Decision Session - Executive Member for Economy and Transport

- 4. The York Parking, Stopping and Waiting (Pages 13 - 198) (Amendment) (No 14/58) Queen Street, York – Traffic Order 2023**

This report seeks the Executive Member to consider the statutory consultation to a traffic regulation order which has been advertised. The proposal includes the removal of the residents parking in front of the terraced cottages on Queen Street, York.

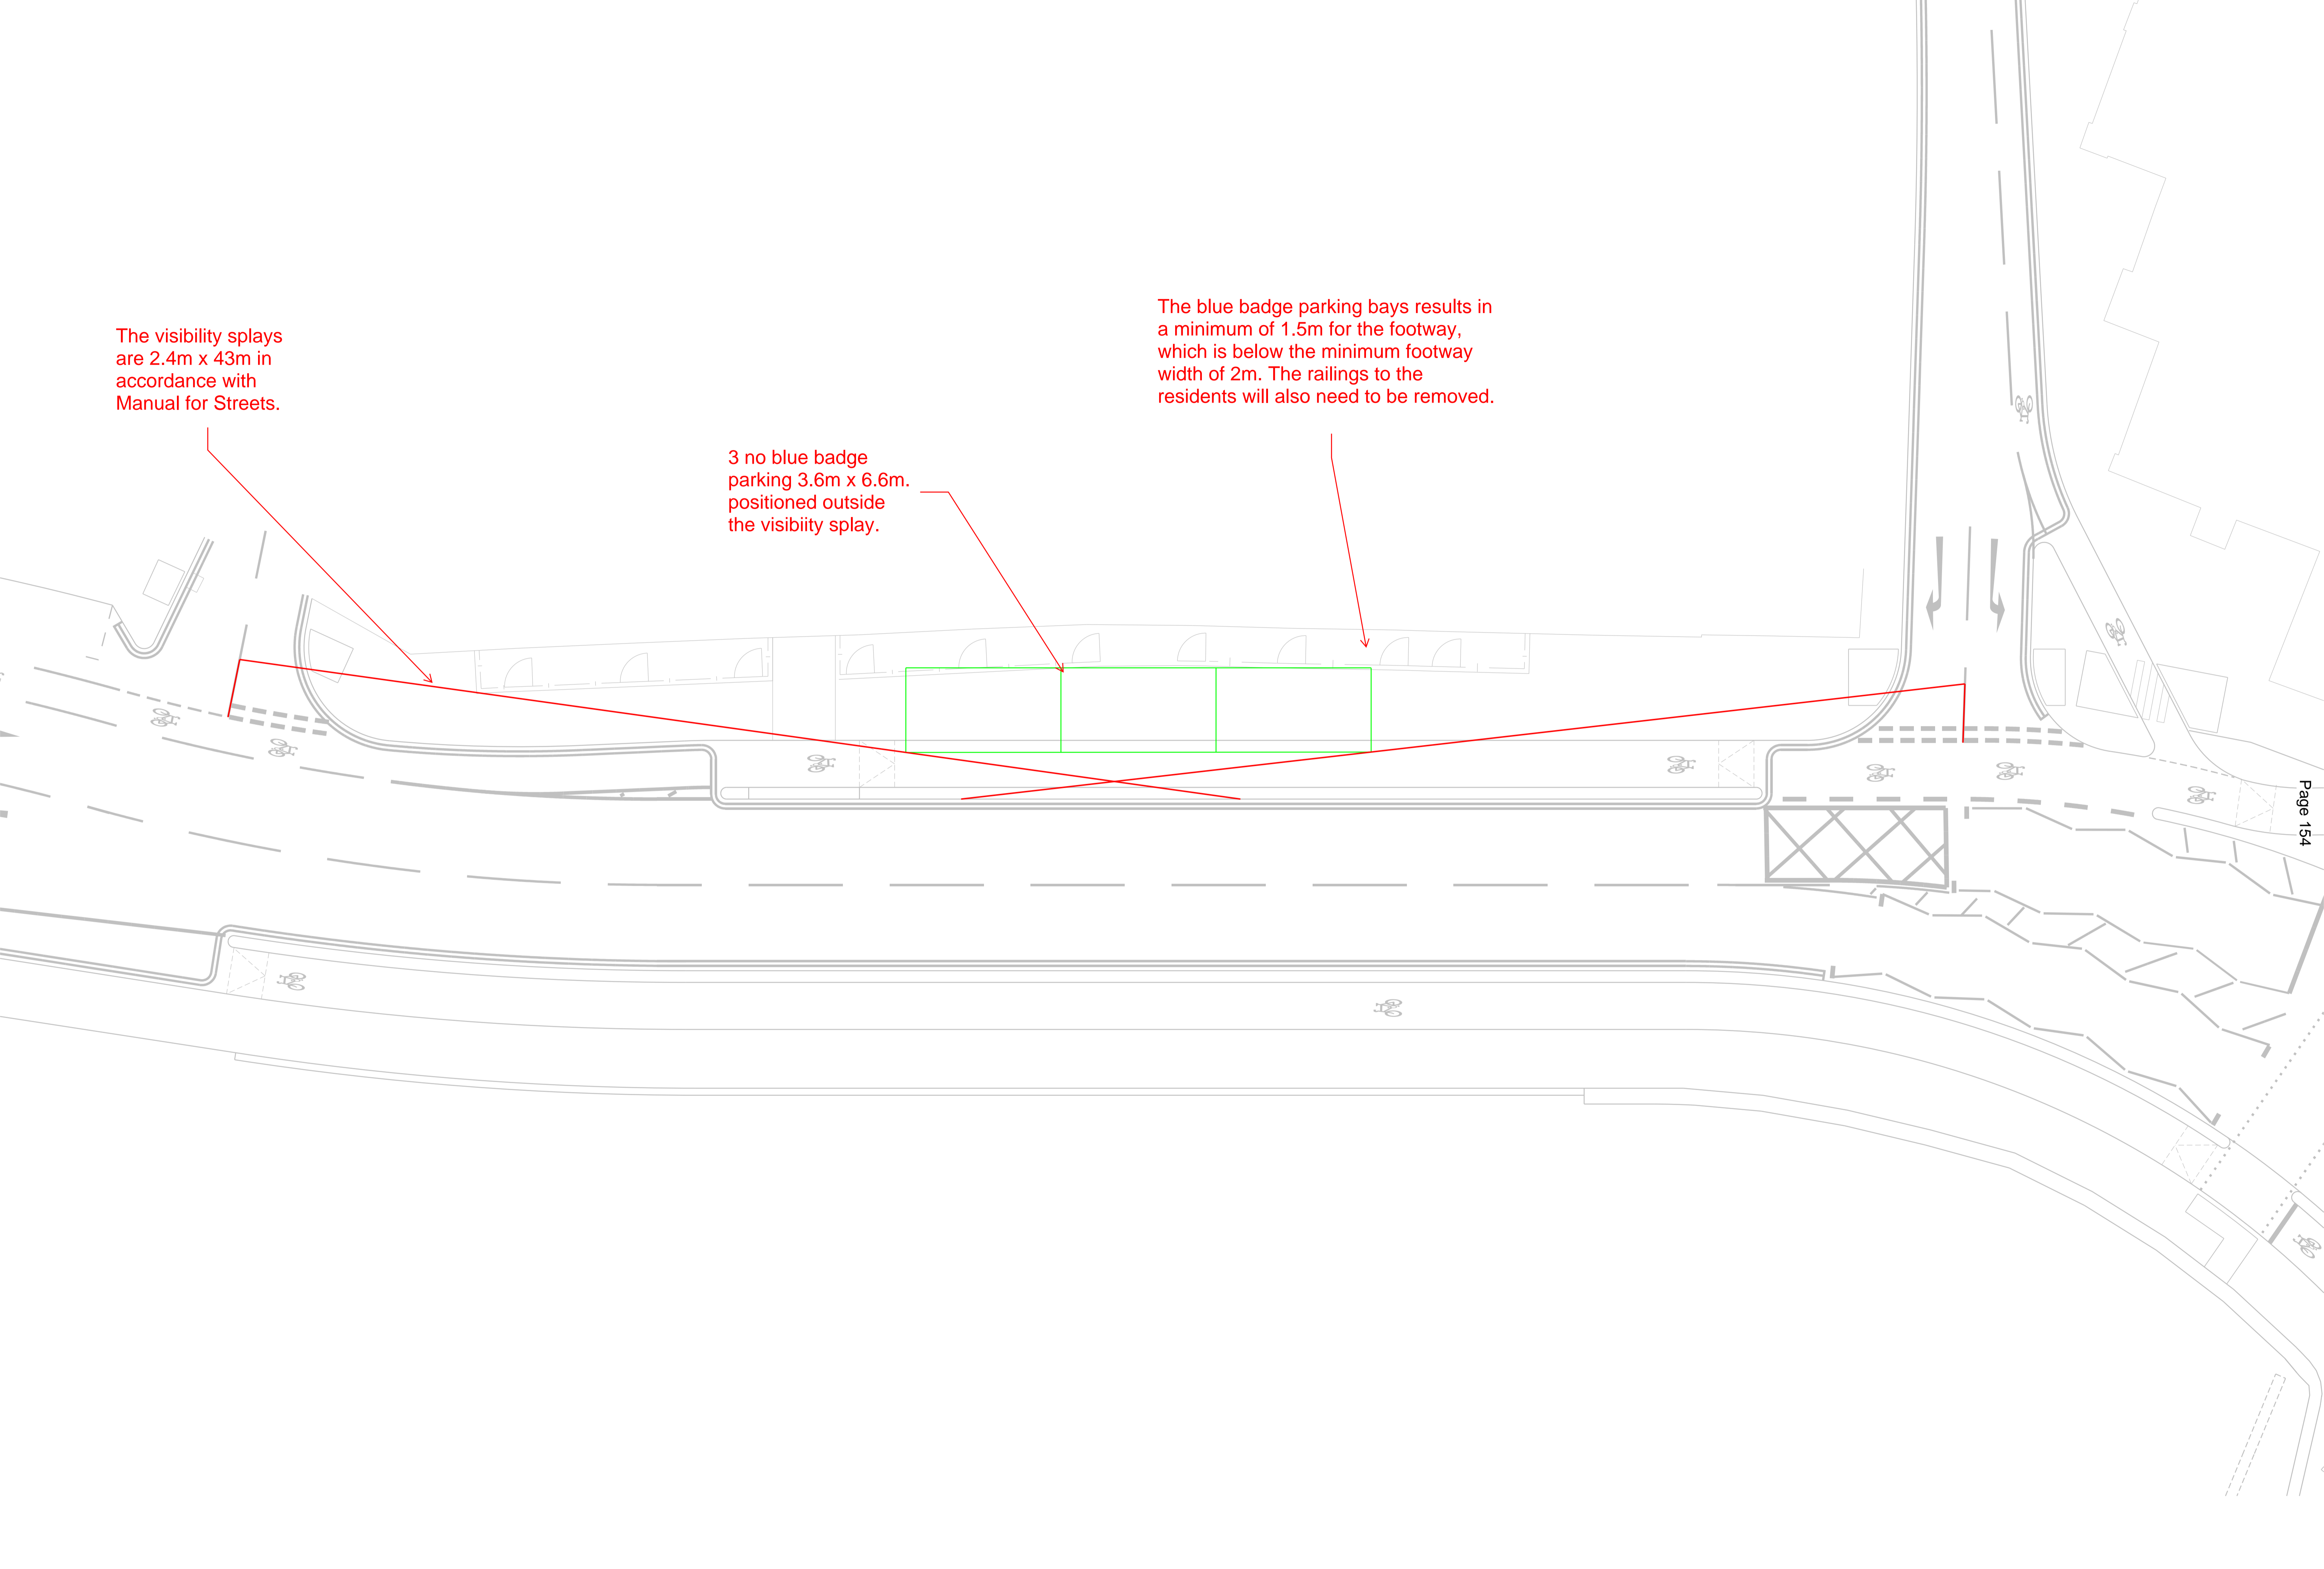
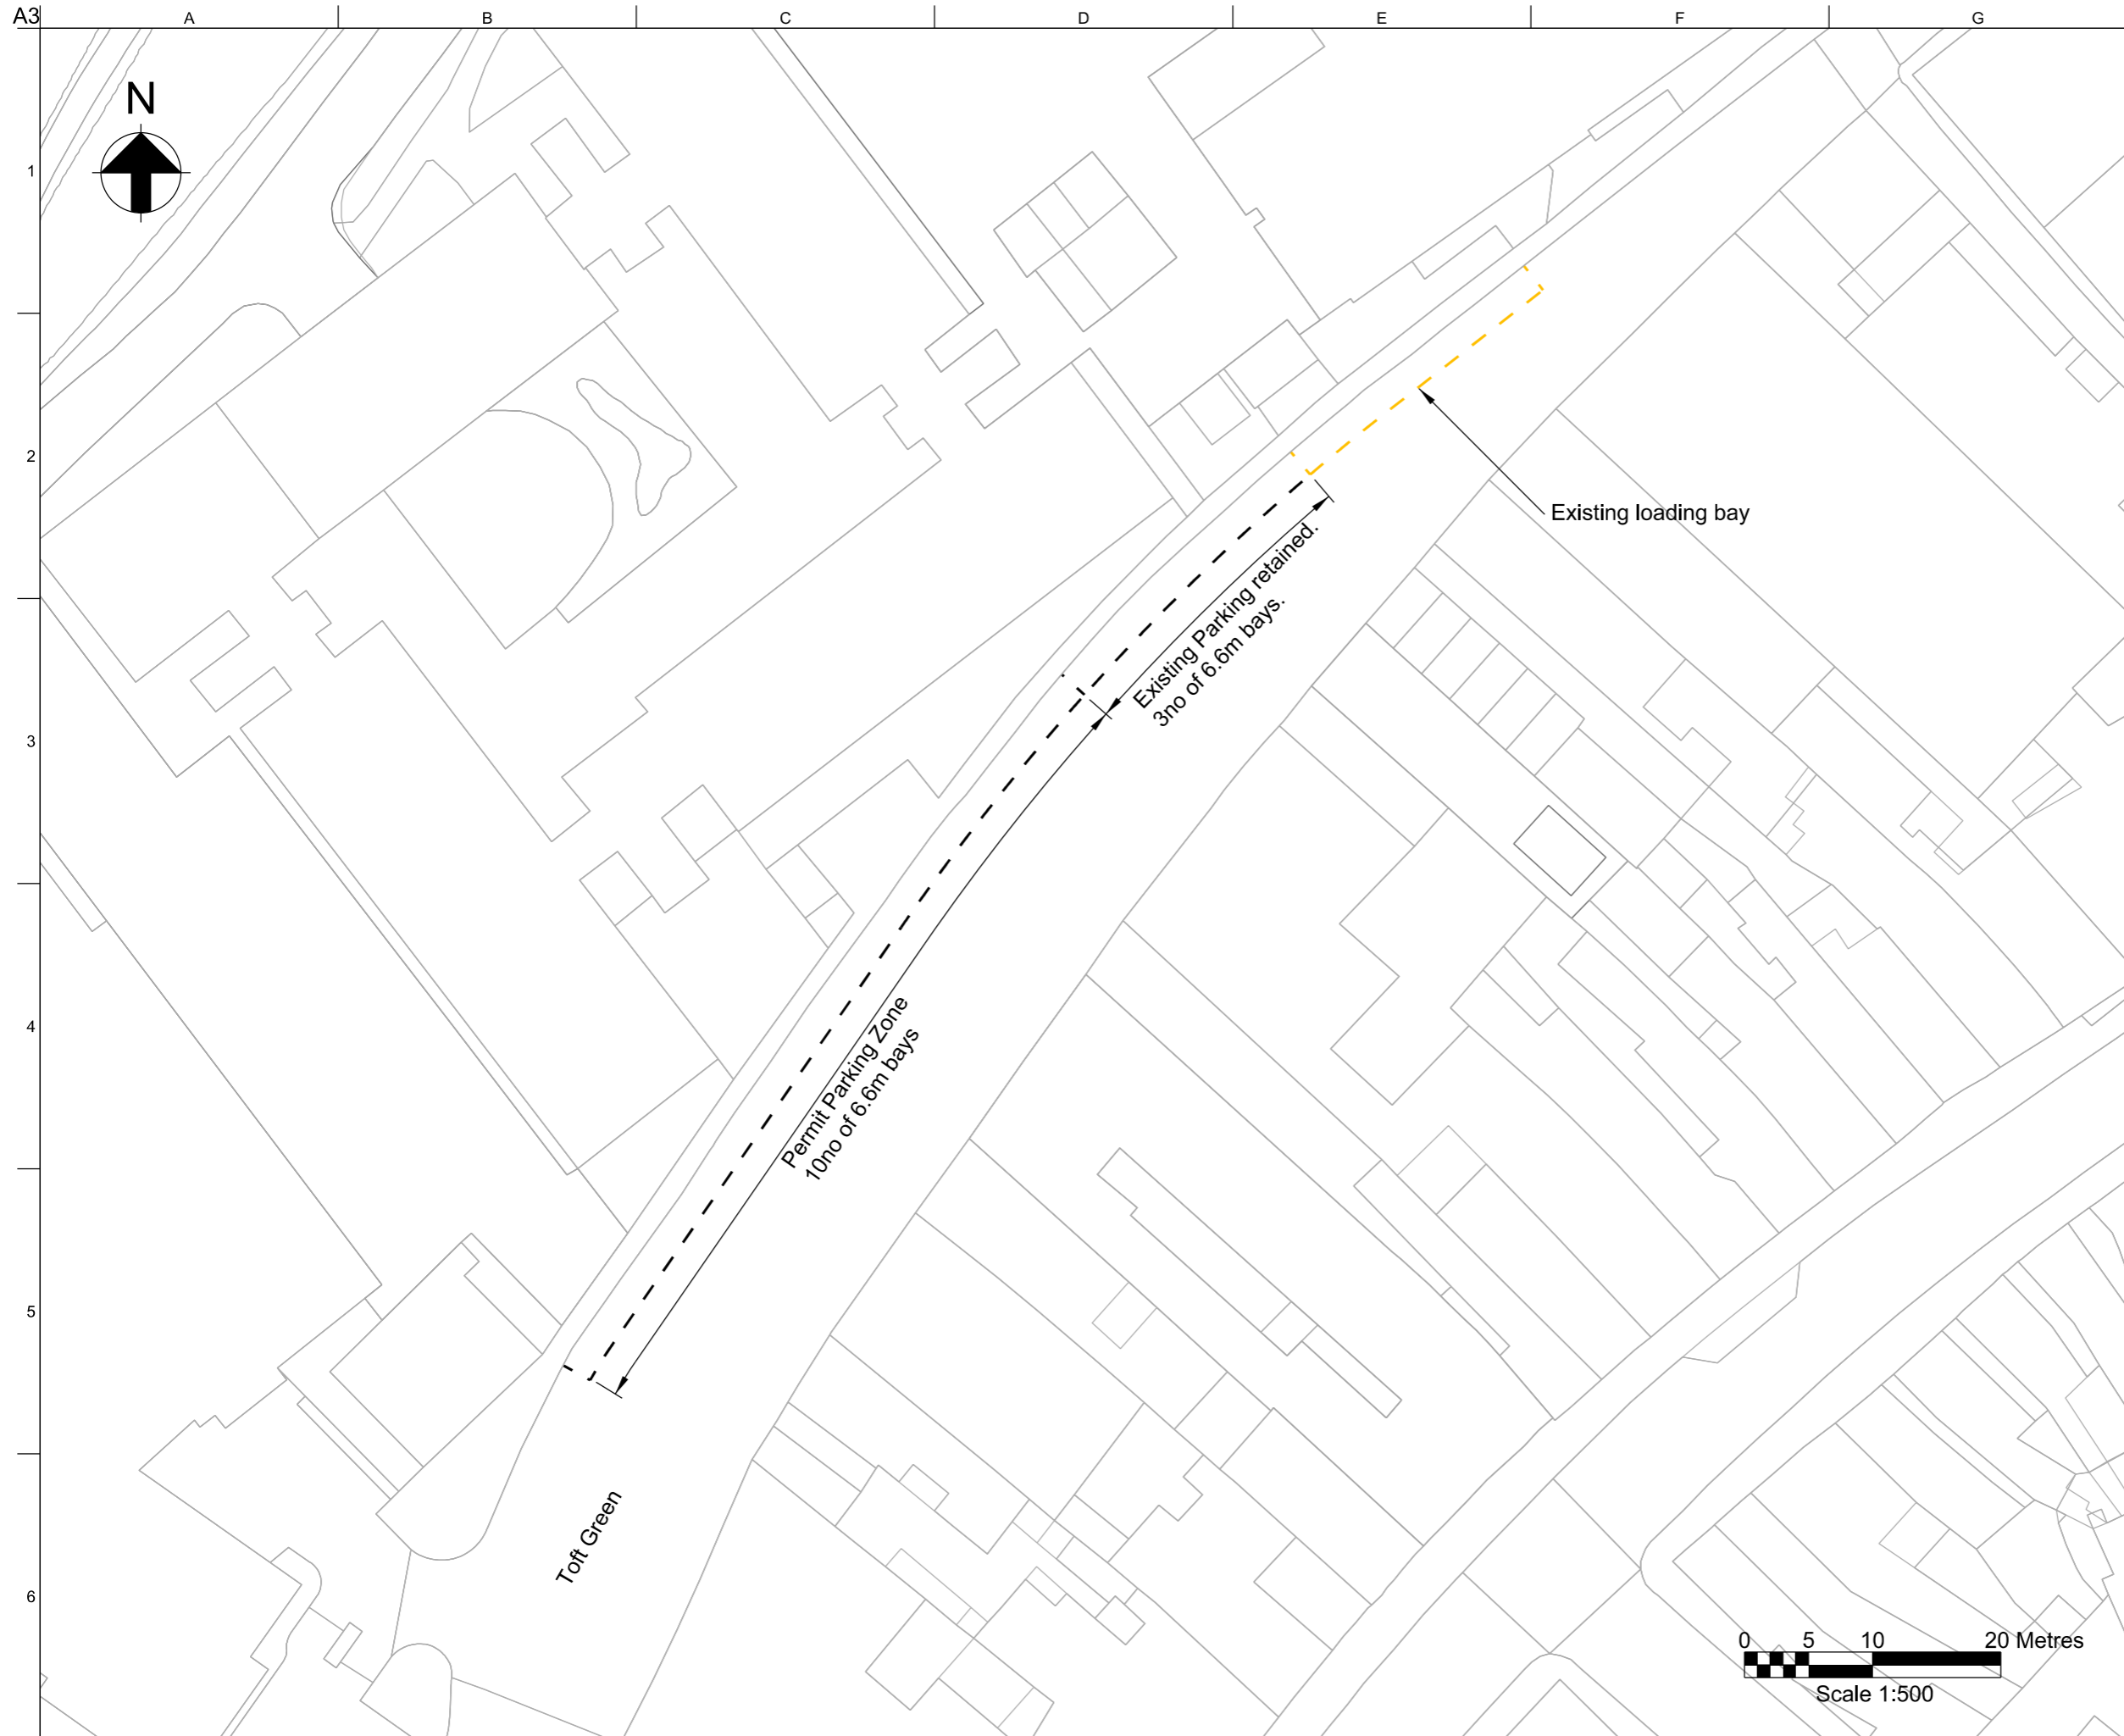
Due to the blue badge parking location a on carriageway cycleway provision will need to be provided. This will result in a total widening of 1.5m to this line.

If a segregated cycleway is to be maintained the full corridor will need to be widened by 3.6m to this line. This will result in works within the existing scheduled monument embankment.

Any carriageway realignment would impact on the design for the realigned City Wall, requiring the wall alignment to be realigned closer to the City Wall and increasing the constructibility risk.
